Product Change Notification

Date Issued :	June 05, 2025	PCN Number :	516998
Reason for Change :	Packaging Method/Quantity Changing		
Description of Change :	This notification is to inform you about part(s) listed will undergo changes for packaging specification change. No changes will be made to product as part of this change.		
Assessment of Change :	Drop Test		
Planned Implementation Date :	December 05, 2025		
Customer Sample Availability Date:	June 30, 2025		
Last date to request Samples by Customer :	June 30, 2025		
Please note if Samples are not requested as per Customer Samples Request date, it may take additional 4-6 weeks to arrange Samples.

Before Picture

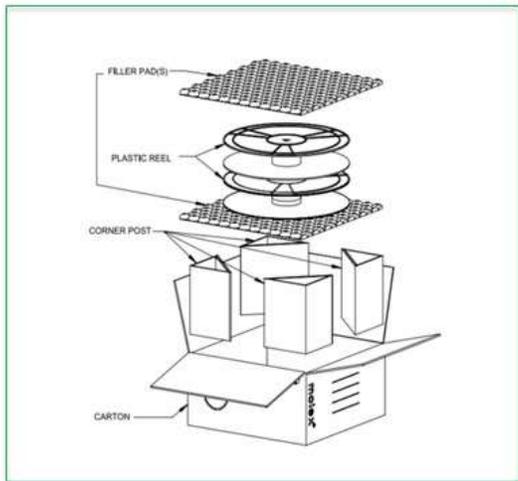
- Remove bubble paper and paper triangle.
- Carrier tape is strong enough to protect our product. Remove additional accessories can be less trash and better material handling.

After Picture

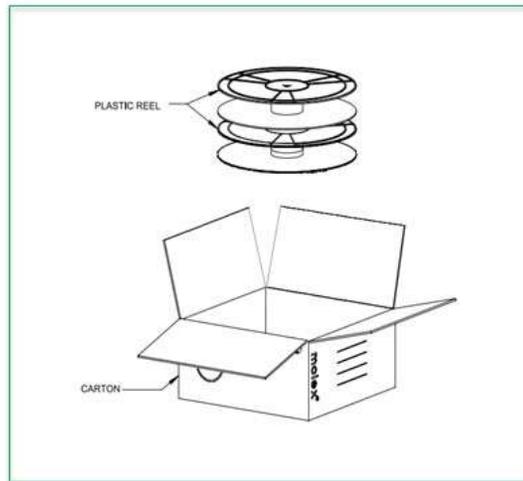
- Product Impact: No impact to fit, form or function. SPQ doesn't change.
- PN impact: ConnTAK50
